"Design, Manufacture, Supply, Installation, Testing and Commissioning of Tunnel Ventilation System & Environmental Control System between BKC (excluding) to Mumbai Central (including) Stations." (Package: 15)

IFB Number: [MM3-CBS-TVE (P2L1)]

Addendum No: 2

ANCILLARY BUILDING PLAN (SHEET 3 OF 4)

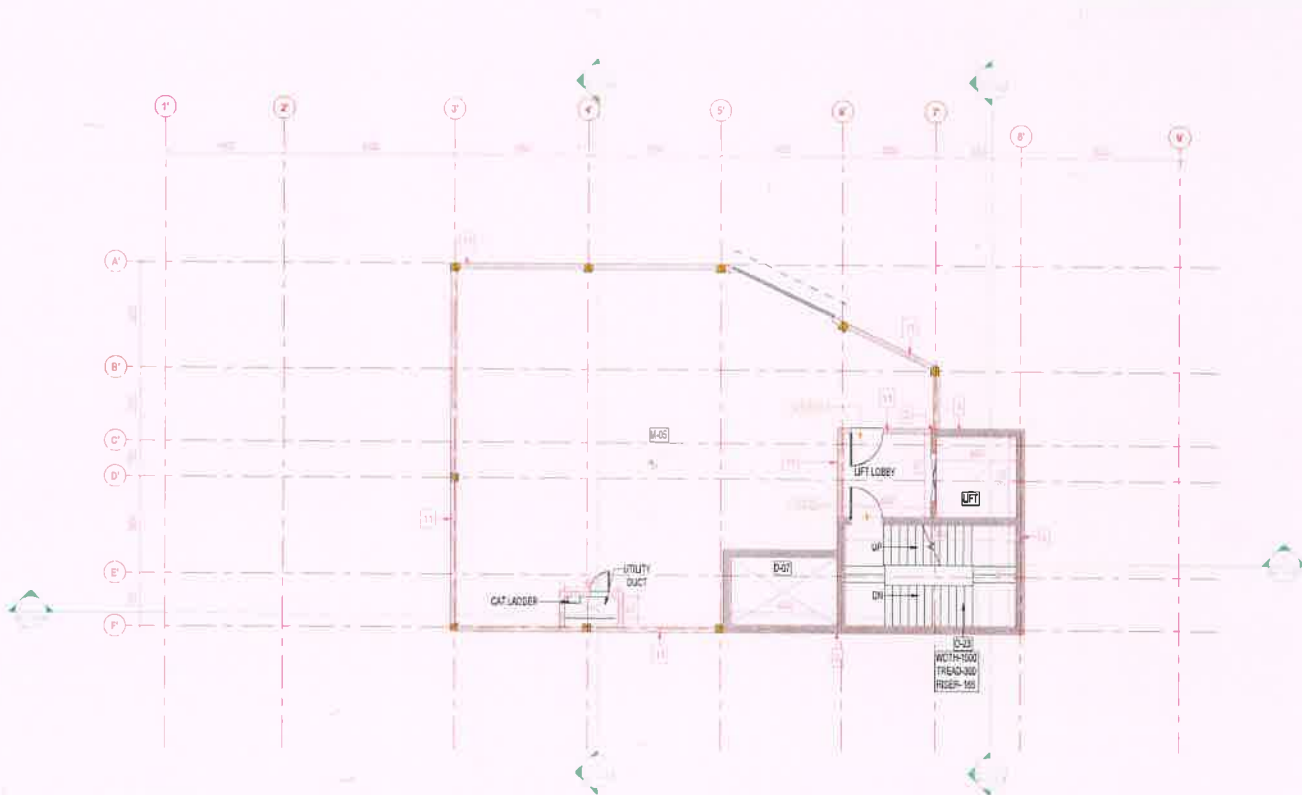
Sr. No.	Description and Clause No.	Amendment
1	Part 1 - Bidding Procedure Section IV-A - Bidding Forms Bid Form 21 FIR-4: Bid Capacity	Replace : Maximum value of works executed in any one year during the last five years (Updated to 2016-17 price level) With: Maximum value of works executed in any one year during the last five years (Updated to 2017-18 price level)
2	Part 4 - Drawings Section X - Drawings	Replace : UGC04-ARP-SDA-4061-003 With: UGC04-ARP-SDA-4061-003 Attachment No. 1 The dosing room is deleted.

PROJECT	MUMBAI METRO LINE 3 COLABA-BANDRA-SEEPZ	STATION	-	DATE	14-03-2018
TITLE	INTERFACE DRAWINGS	DRAWING TITLE	TUNNEL VENTILATION AND ENVIRONMENTAL CONTROL SYSTEM SCADA DRAWING	SCALE	NTS (A1)
DRAWING NO	GCC-TVE-PH-0001-041_A1

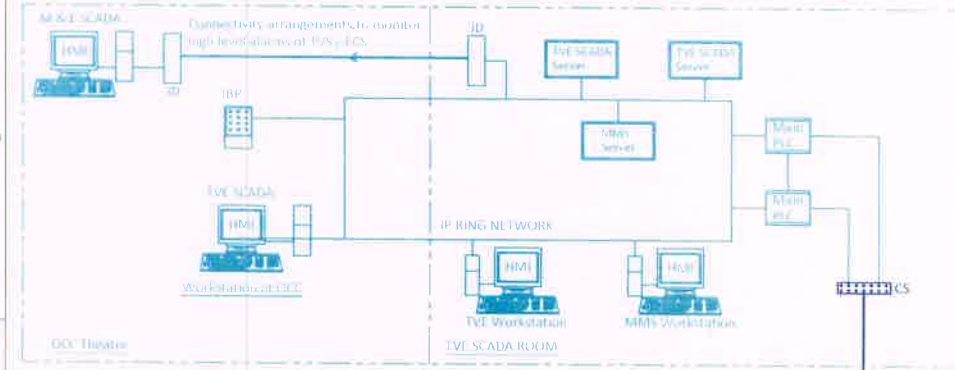
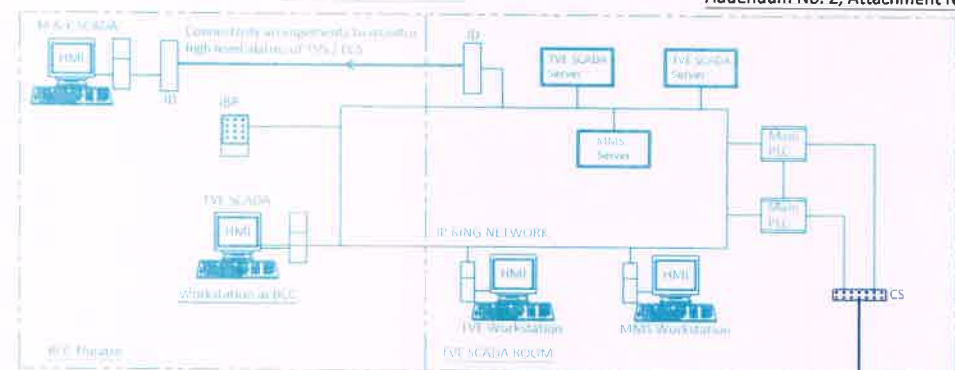
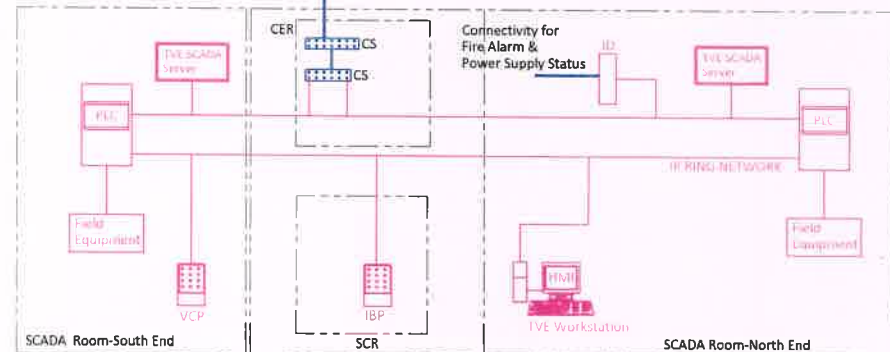
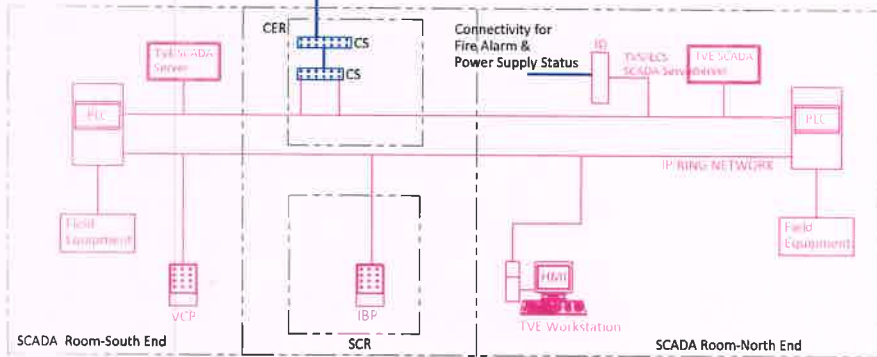
REV.	DATE	PREP.	APPROVED	DESCRIPTION	NAME	SKN
1	10.12.18	AKS	INC	Scope of OCC/ BCC work updated		
					DRAWN BY	
					CHECKED BY	
					APPROVED BY

Note- OCC/BCC scope of work is under TVE-PH-1 contractor
